# HUSQVARNA TECHNICAL BULLETIN HTB2207

JULY 25, 2022

## CONTINENTAL TKC 80 TIRE RECALL

**Attachment no. 2 – how to identify Tire line, DOT Plant + TIN Code and Production Week**

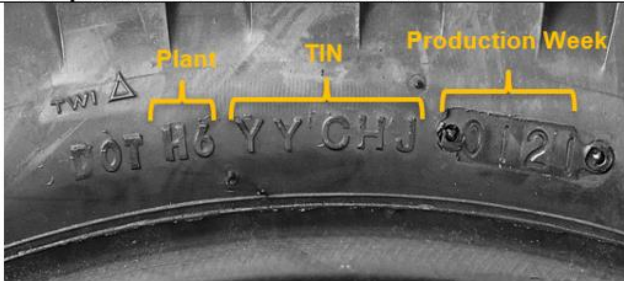
The subject tires were sold as replacement and original equipment tires. The tires must match both the tire line, full DOT tire identification number (TIN) and production period to be part of the recall:

1. Tire Lines – TKC80 tire line
2. DOT TIN's – see list of affected articles shown in Attachment no. 1 below
3. Production period: 0119 to 1722

Examples for full identification see Attachment no. 2.
